DUKE POWER COMPANY

Re: Catawba Nuclear Station
Docket Nos. 50-413 and 50-414

By letter dated September 10, 1985, Duke proposed an amendment to the Technical Specification for the reactor trip setpoint on 10-10 steam generator water level for Catawba Unit 1. This letter provides supplemental information with respect to the earlier submittal.

JUSTIFICATION AND ANALYSIS OF NO SIGNIFICANT HAZARDS CONSIDERATION

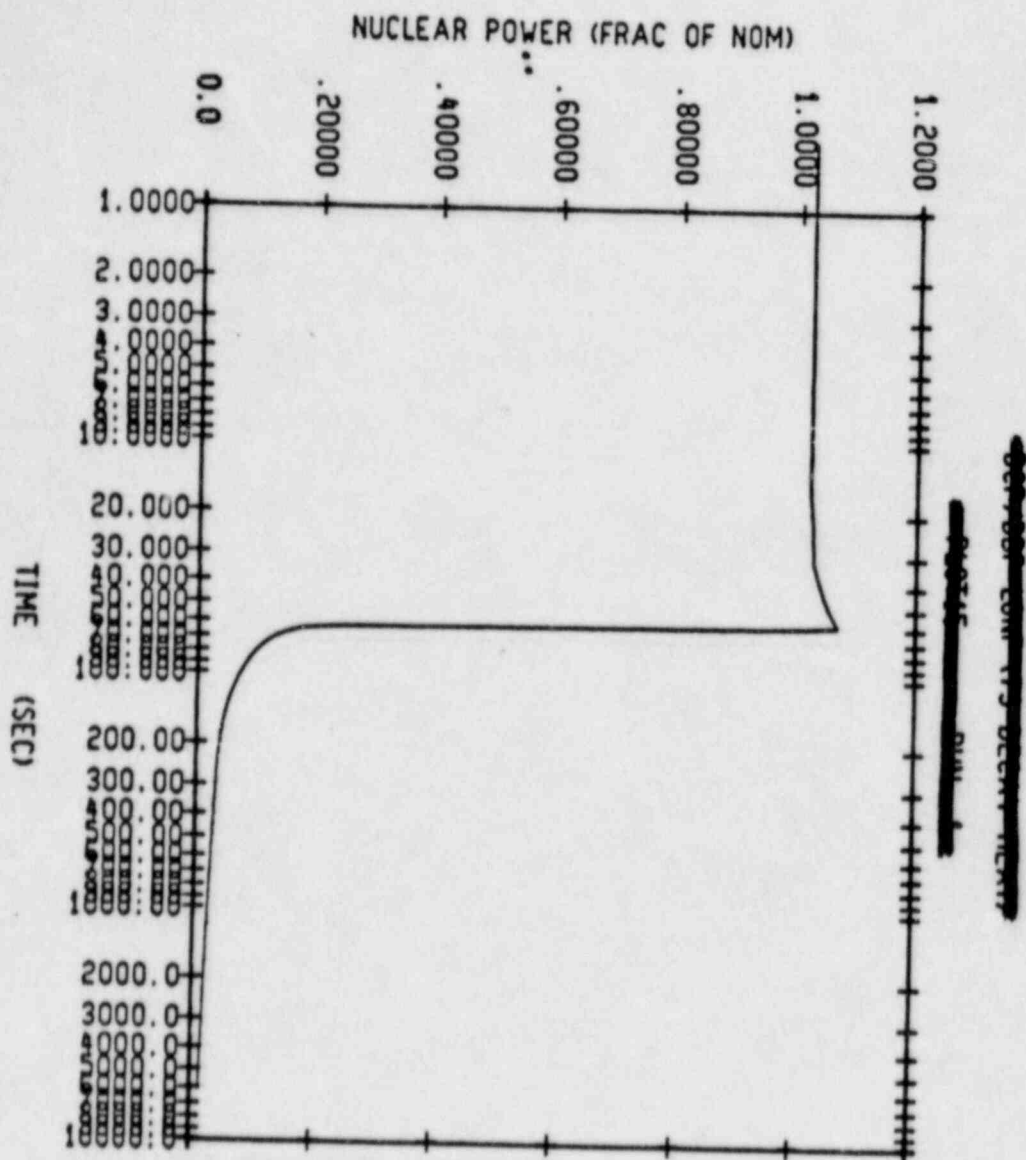
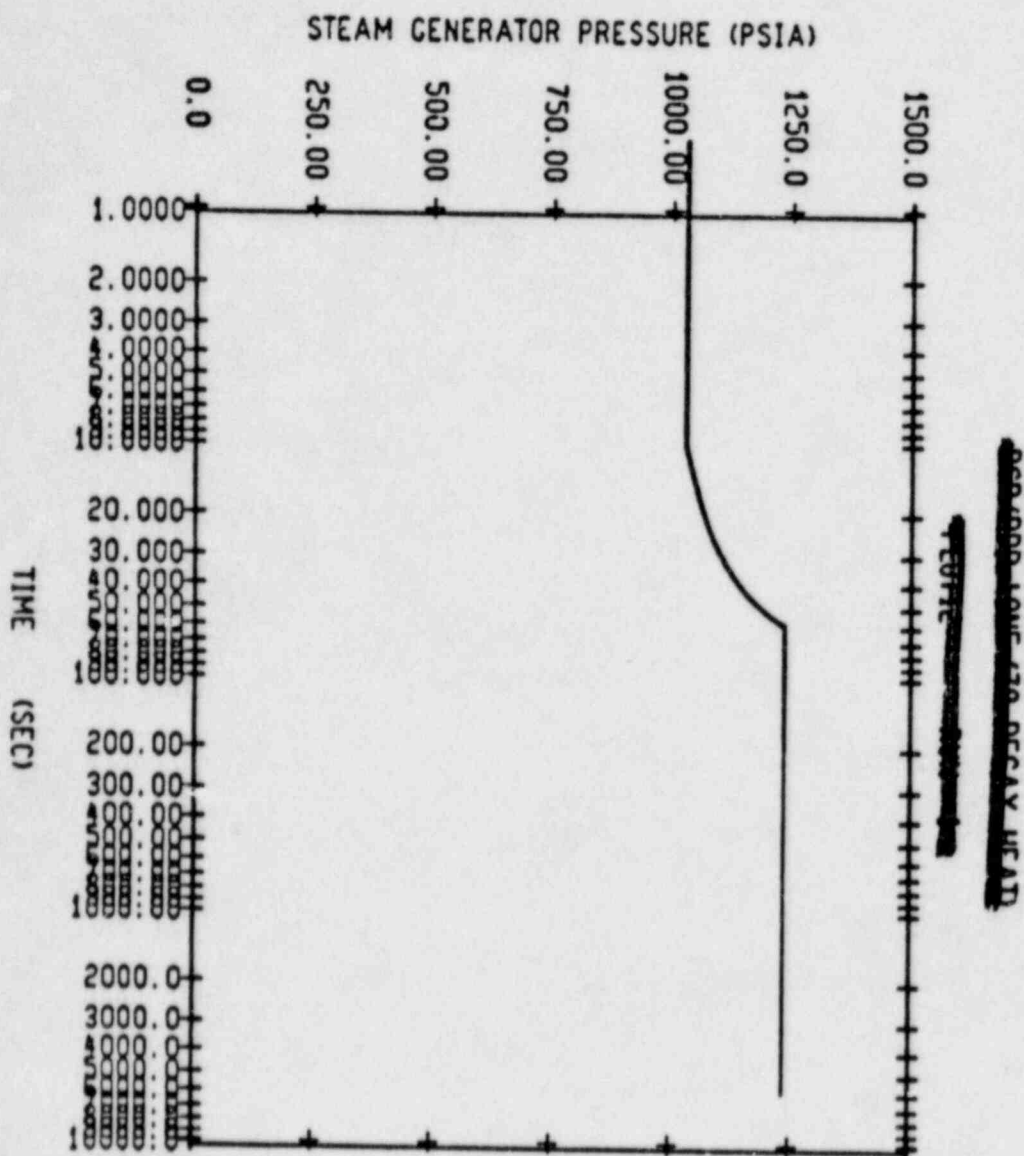
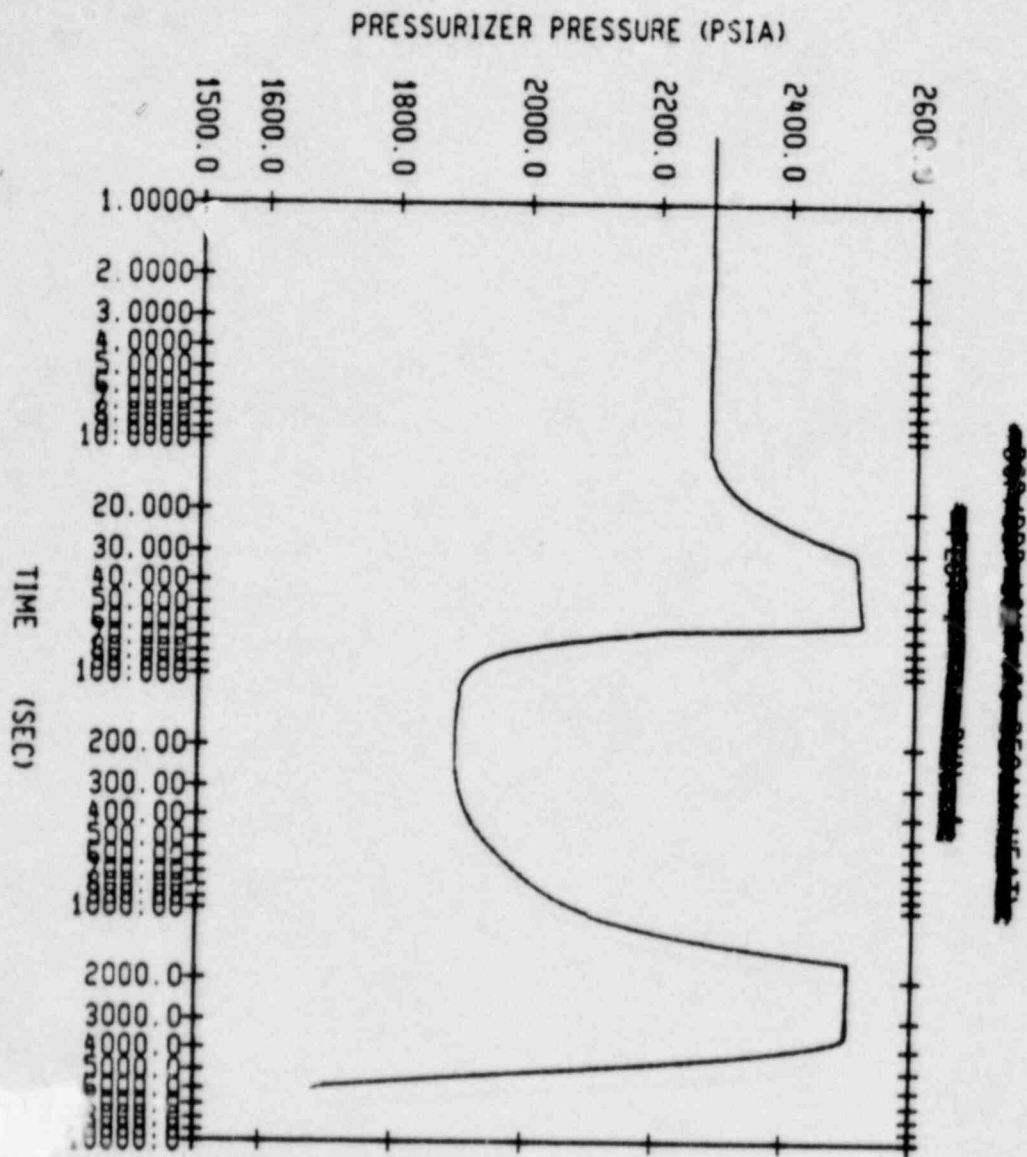
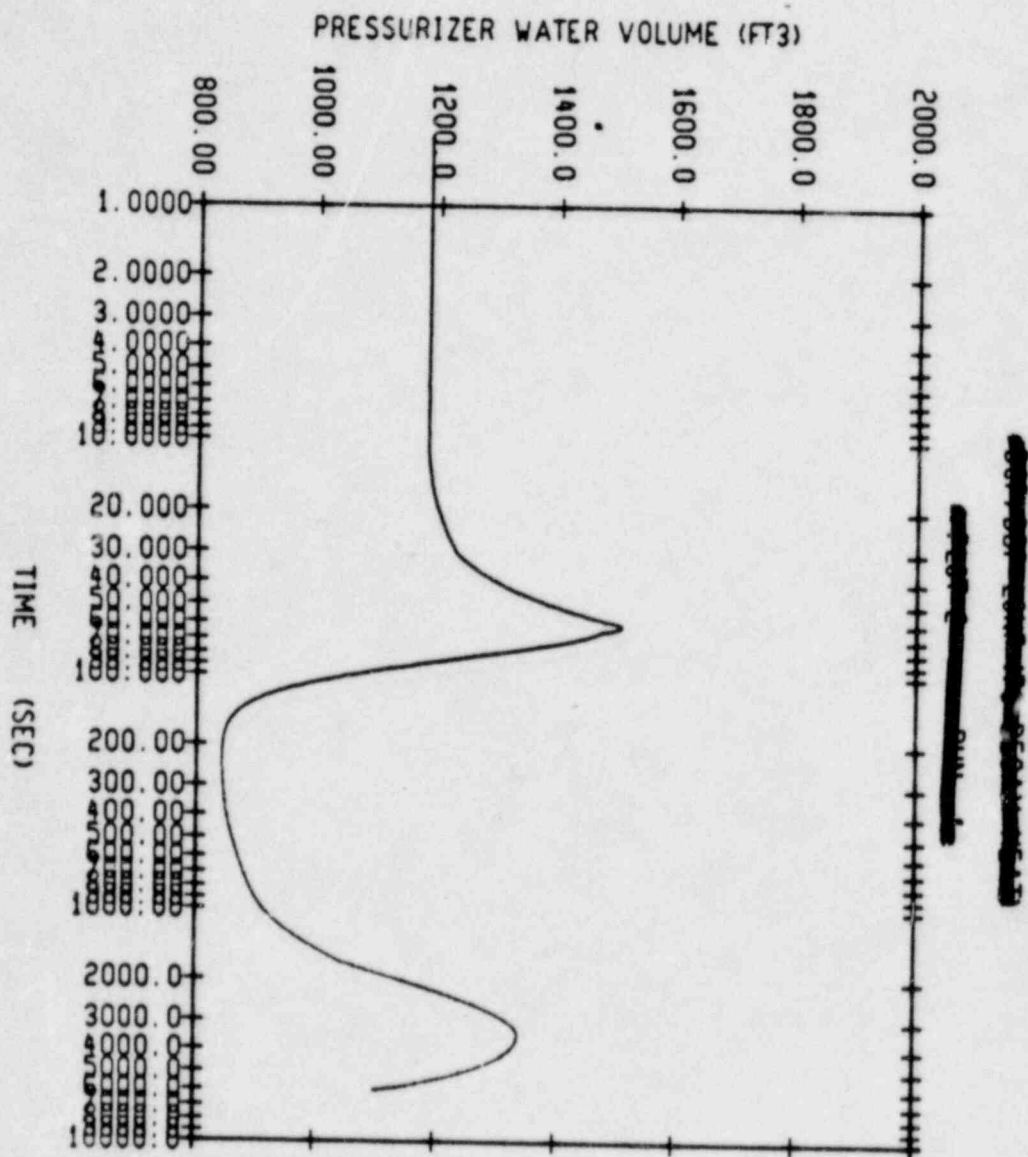
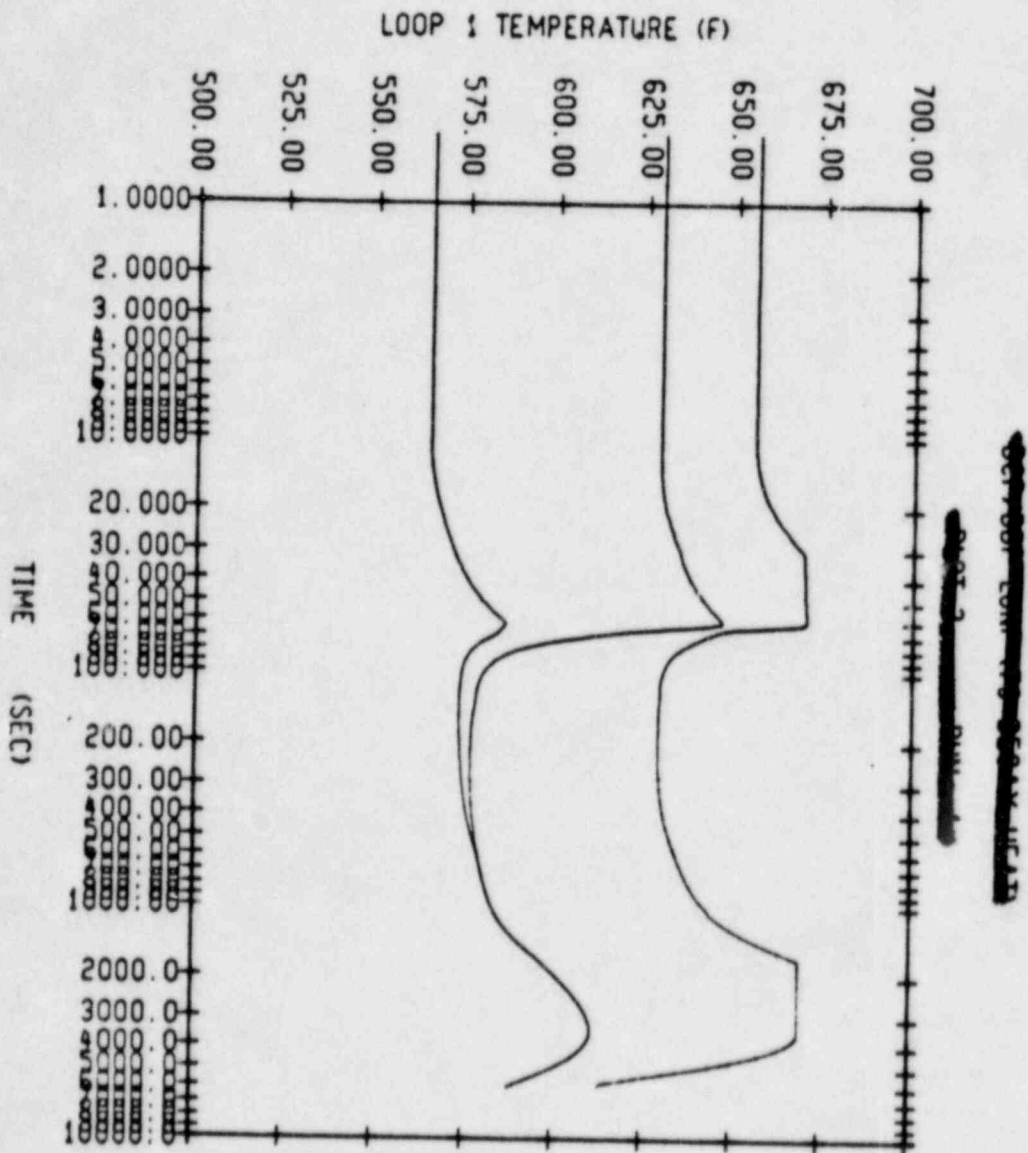
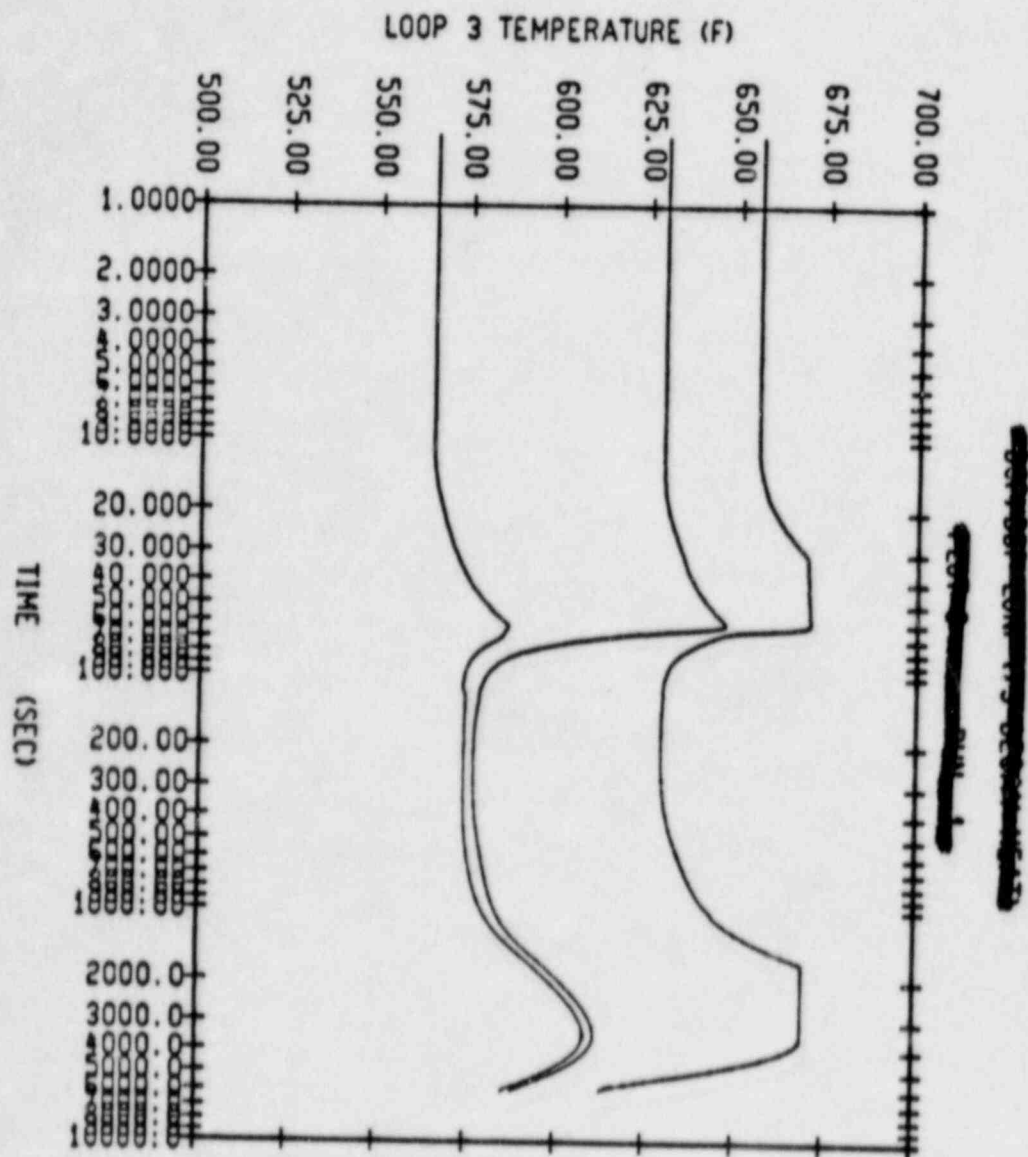
Figures 15.2.7-1, ~~15.2.7-2, and 15.2.7-3~~ ^{through 15.2.7-X3} show the significant plant parameters following a loss of normal feedwater.

The capacity of the Auxiliary Feedwater System is such that the water level in the steam generators being fed does not recede below the lowest level at which sufficient heat transfer area is available to dissipate core residual heat without water relief from the RCS safety valves. Figure 15.2.7-1 shows that at no time is there water relief from the pressurizer. 15.2.7-2

The calculated sequence of events for this accident is listed in Table 15.2.3-1. As shown in Figures 15.2.7-1 and 15.2.7-2, the plant approaches a stabilized condition following reactor trip and auxiliary feedwater initiation. Plant procedures may be followed to further cool down the plant.
